ADDENDUM NO.: 01
PROJECT NAME: Lincoln Park High School Renovation Project
PROJECT NO.: 05085
CONTRACT NO.: C1582
DATE OF ISSUE: April 27, 2017

NOTICE OF CHANGES, MODIFICATIONS, OR CLARIFICATIONS TO CONTRACT DOCUMENTS

Sheet **P0.03**

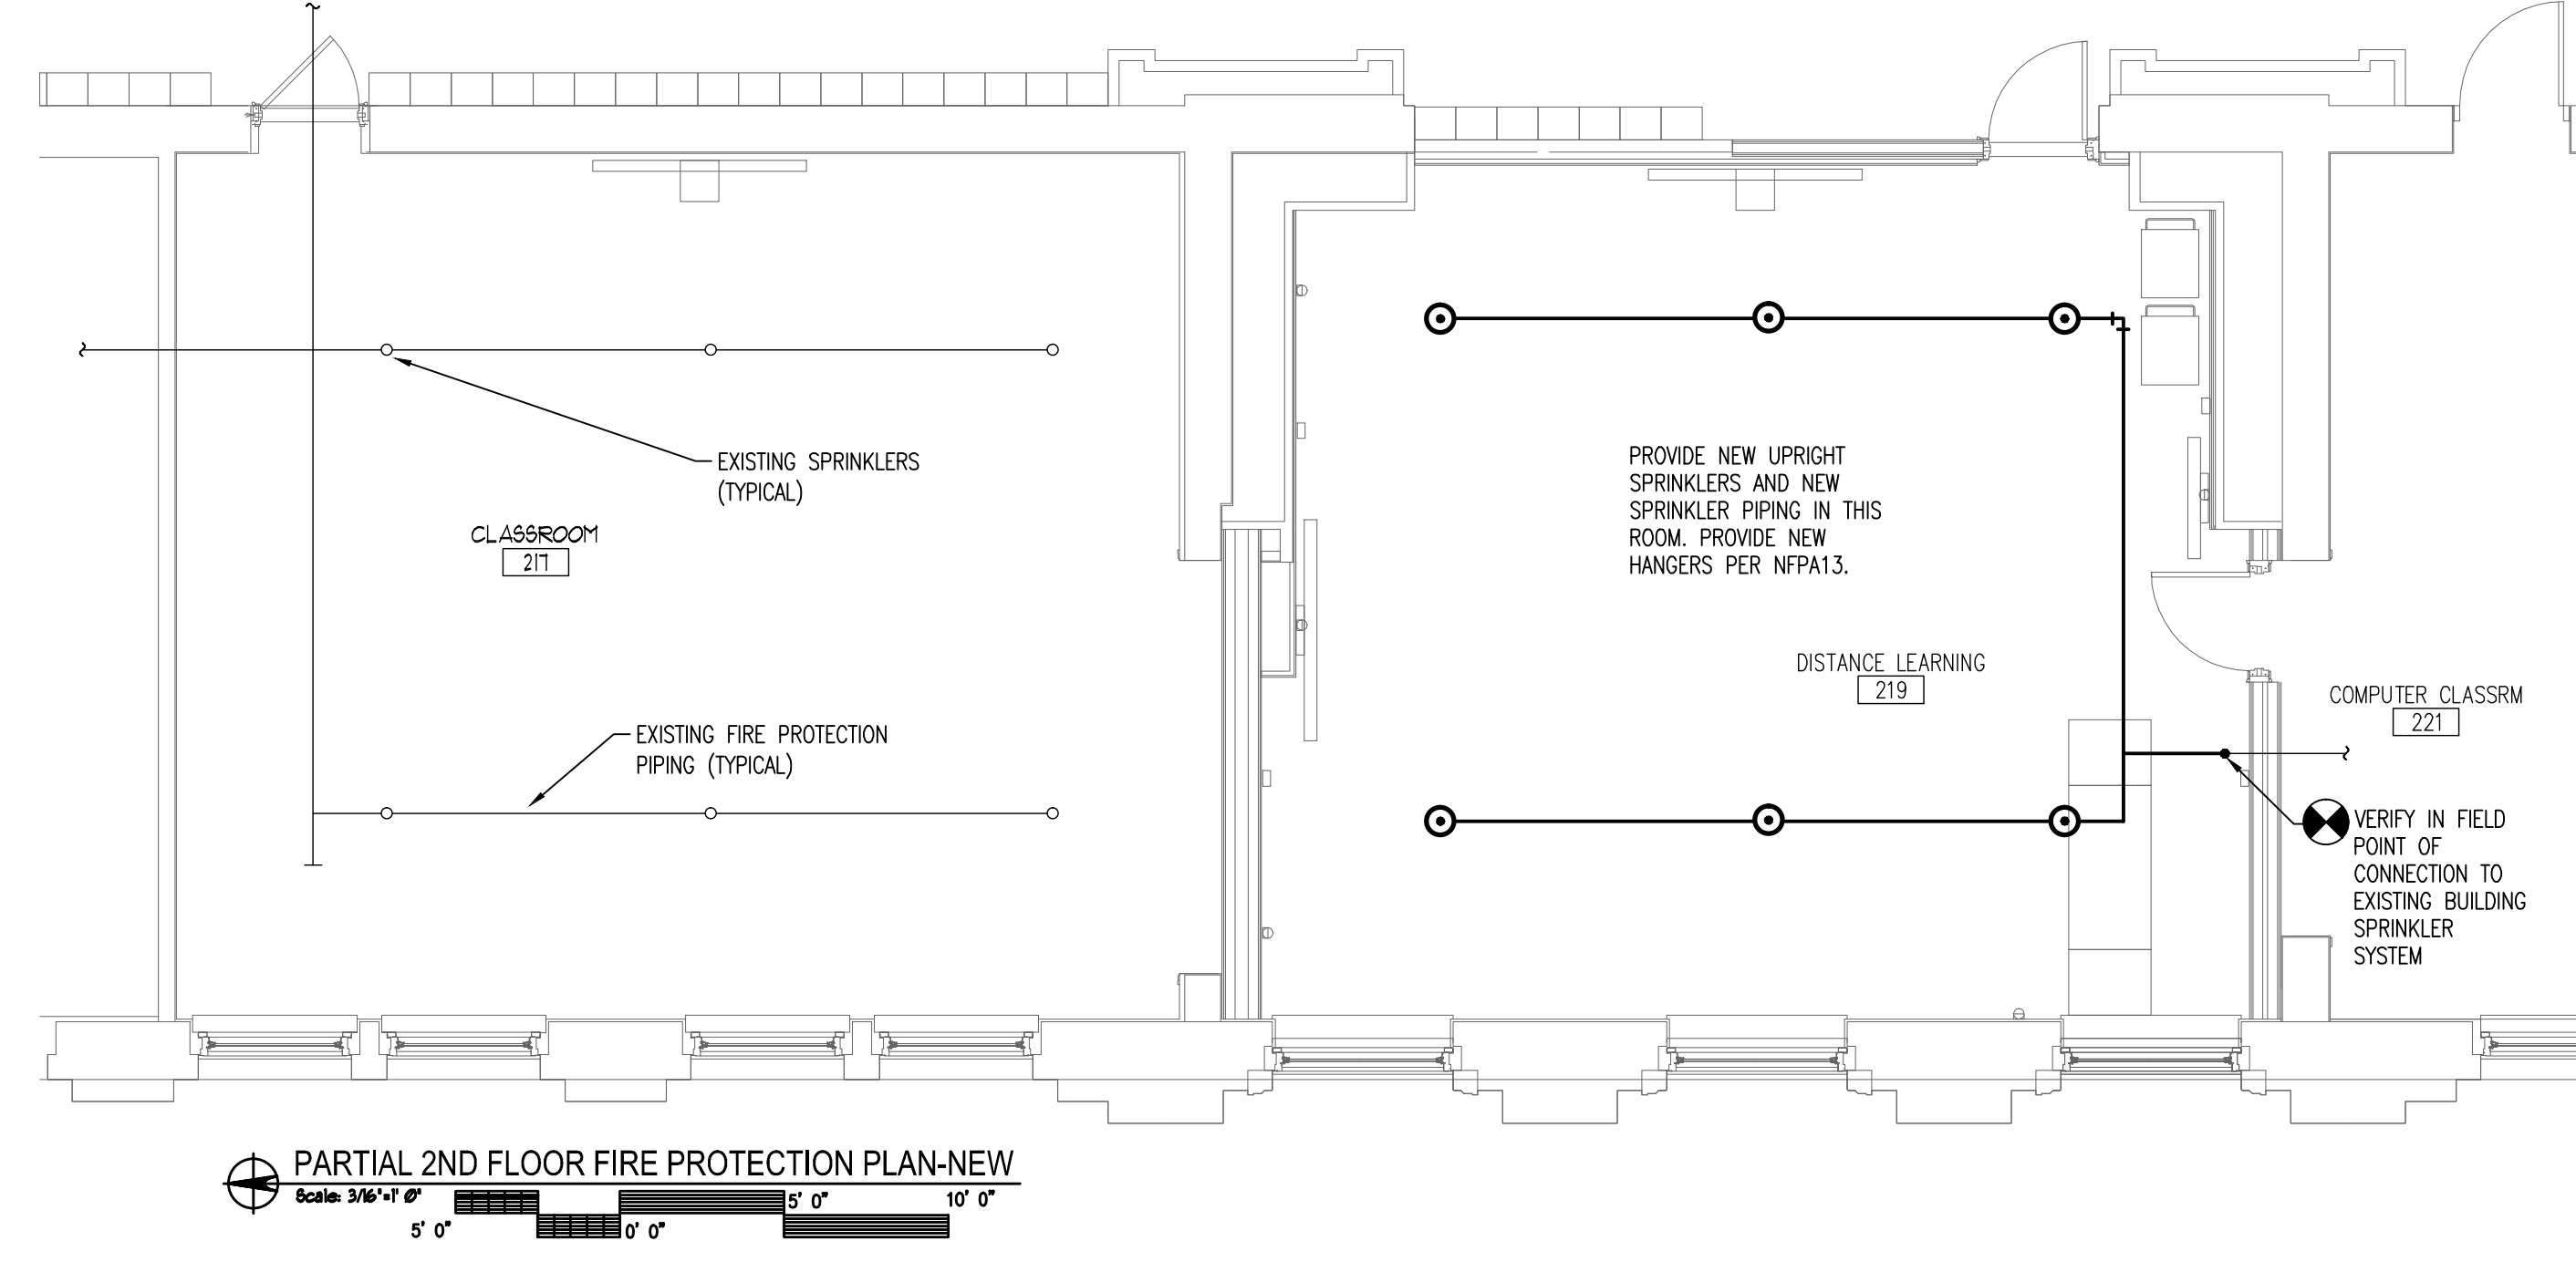
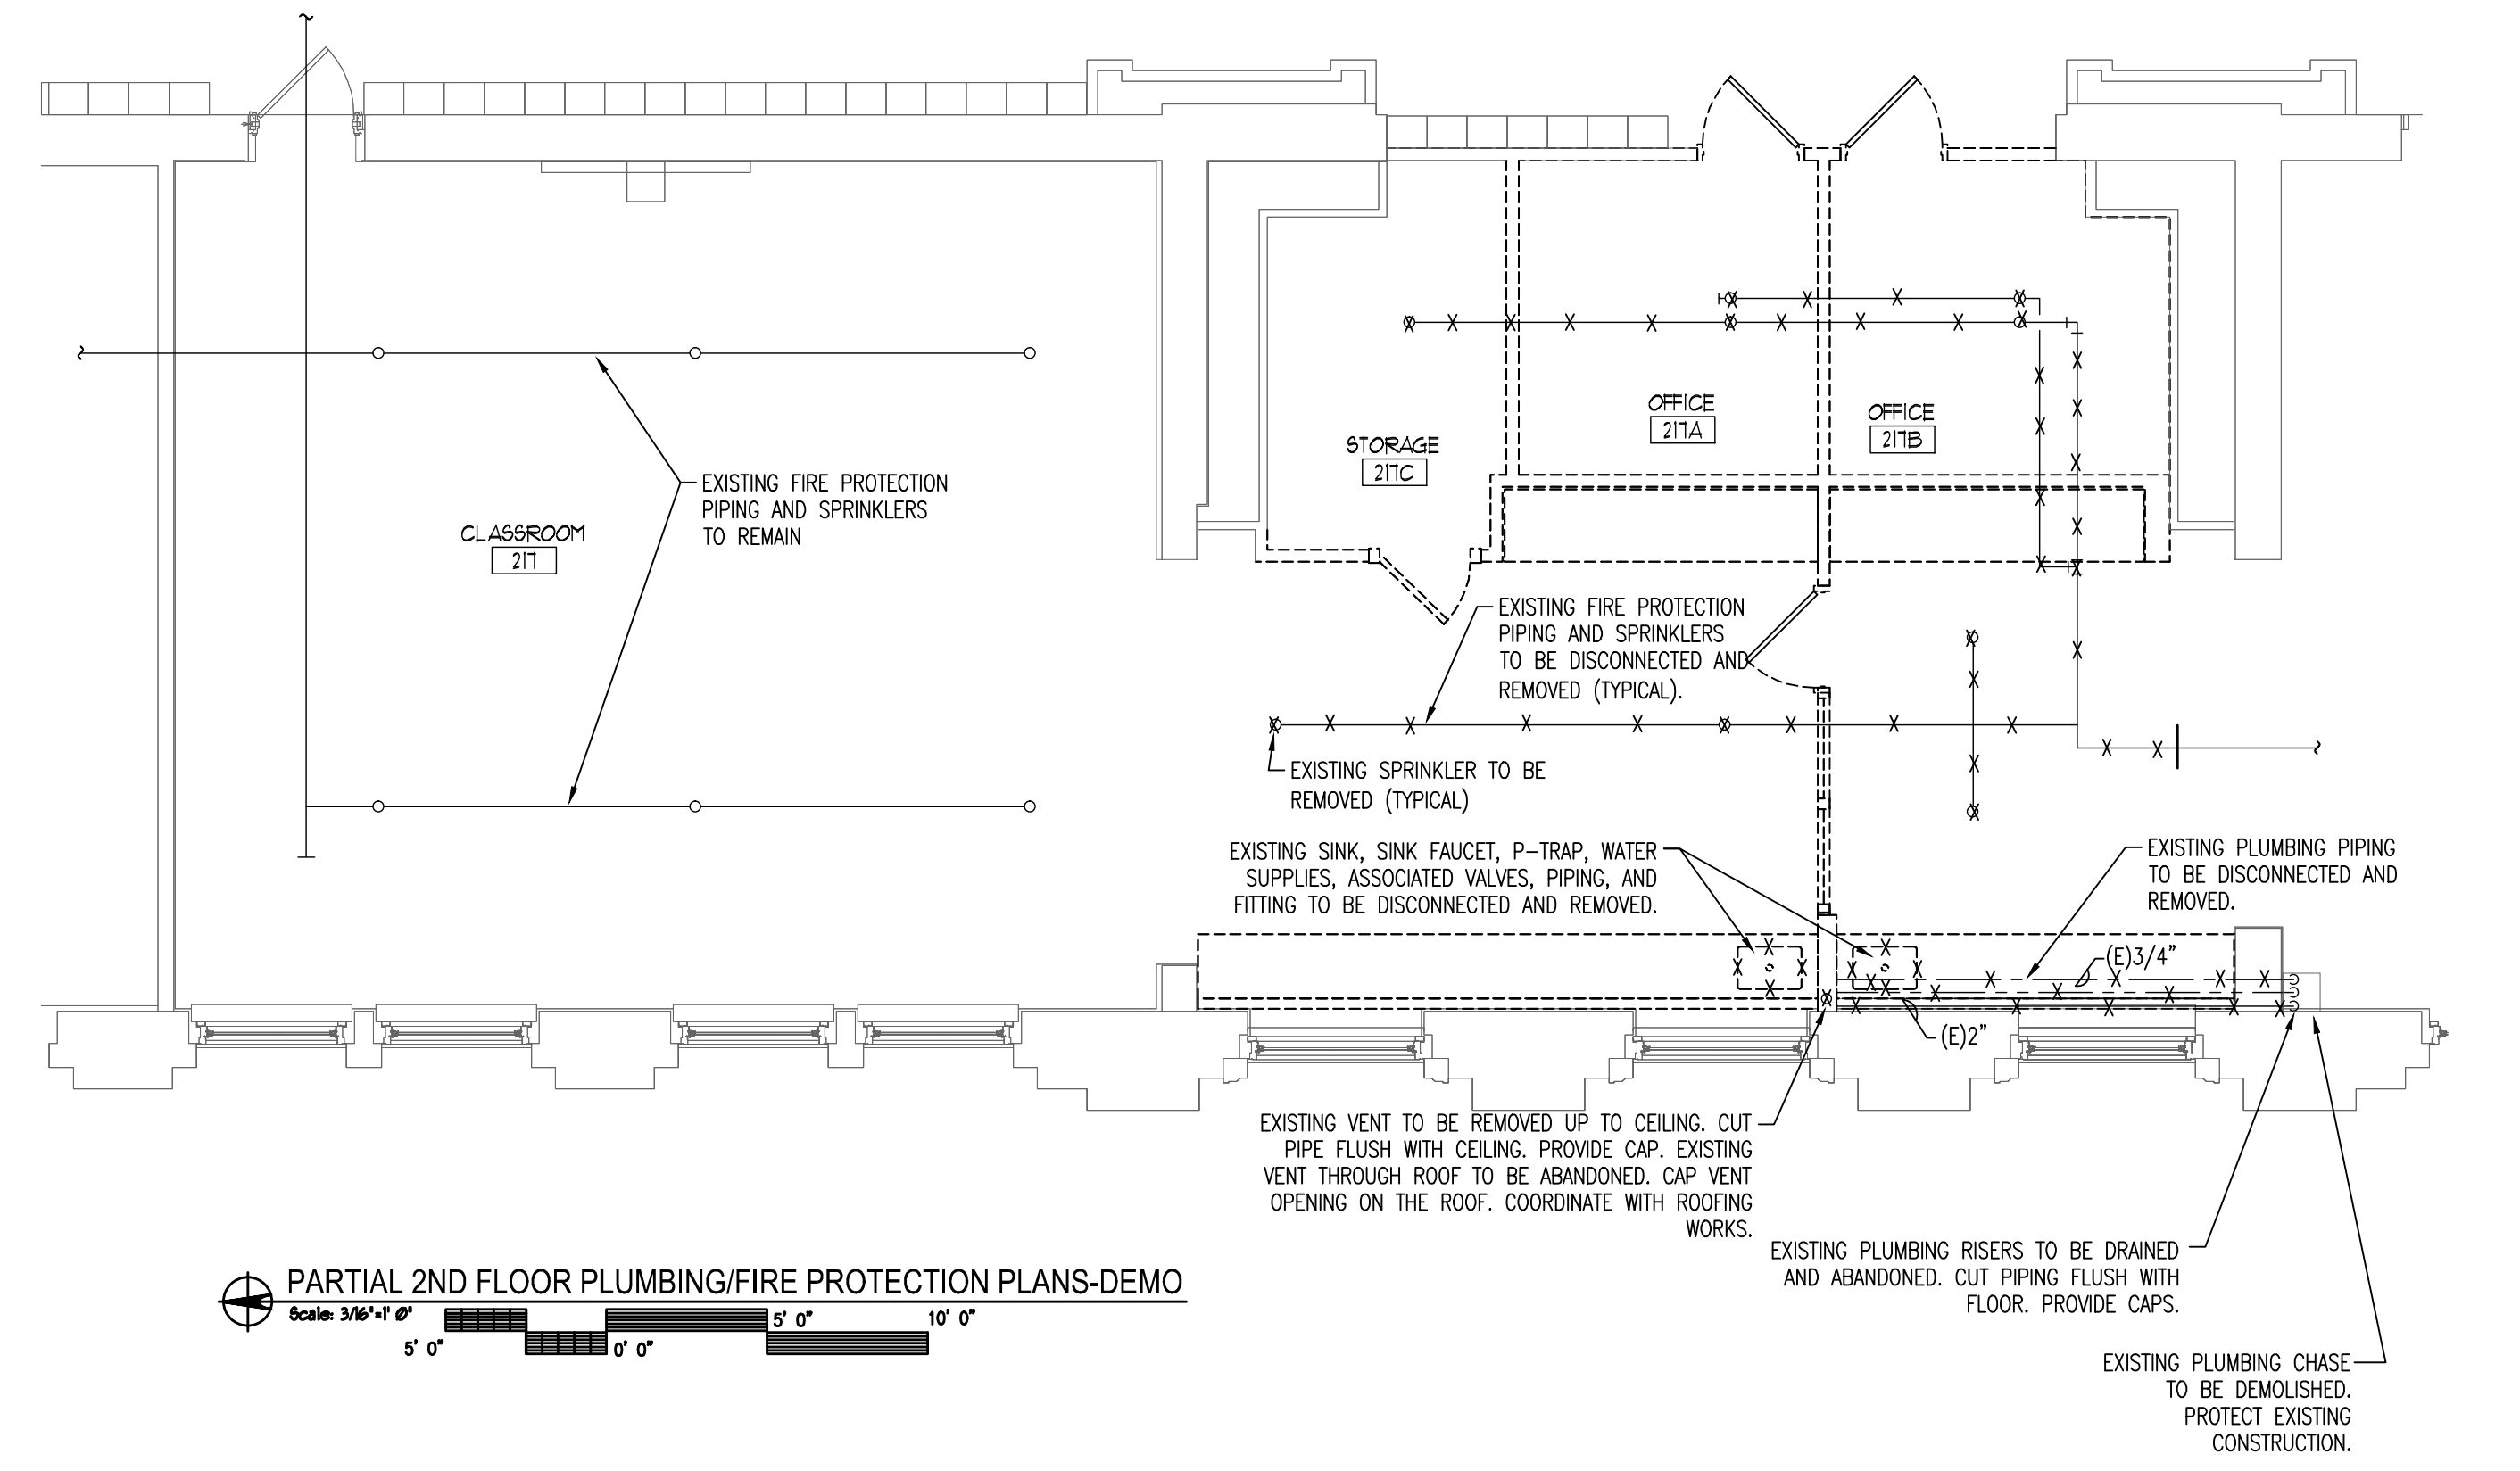
- Change No. 23 Sheet P0.03 ADD: Removal and replacement of fire protection piping and sprinklers in Distance Learning 219.
- Change No. 24 Sheet P1.02 ADD: Removal and replacement of vertical storm water pipe located in Basement.
